Clean Water Act (CWA) Inspection Report

The HD Fowler HR-3 Industrial Stock Yard construction project (hereinafter referred to as the "Project") is permitted to discharge to the Highway-3 Ditch under the CGP, the permit tracking number assigned to the project is (WAR312451). Based upon my review within Ecology's Permitting and Reporting Information System (PARIS), the initial permit application (notice of intent) for the construction project was submitted by Mr. Boeck on April 6, 2024. Permit coverage was effective on May 18, 2023. See **Attachment A**, Permit Coverage Letter. No prior EPA/Ecology inspection/enforcement activity had been previously documented.

HD Fowler SR-3 Industrial Stock Yard
Site Development Activity Permit

Photo #:01 (DSCN3510)
Description: Photo within the jobsite trailer, “SWPPP Site Map” posted on the wall.

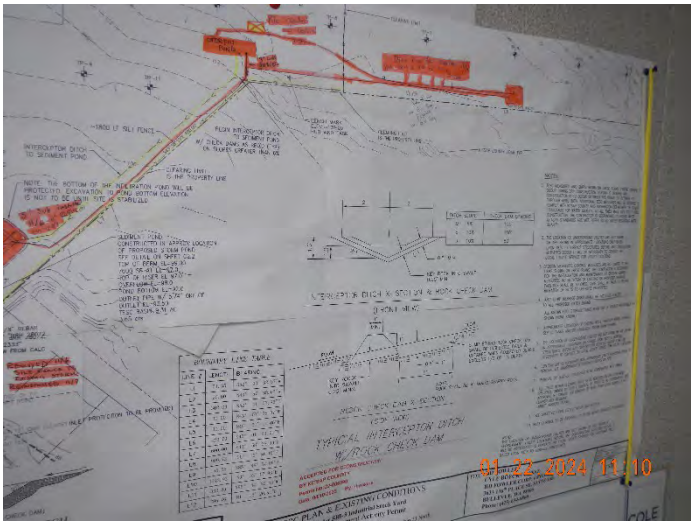
The Project's Site Map was located within the job-site trailer and posted on the wall. The Site Map contained handwritten notes of BMP install dates, locations, and general comments (Photo 1 & Photo 2).
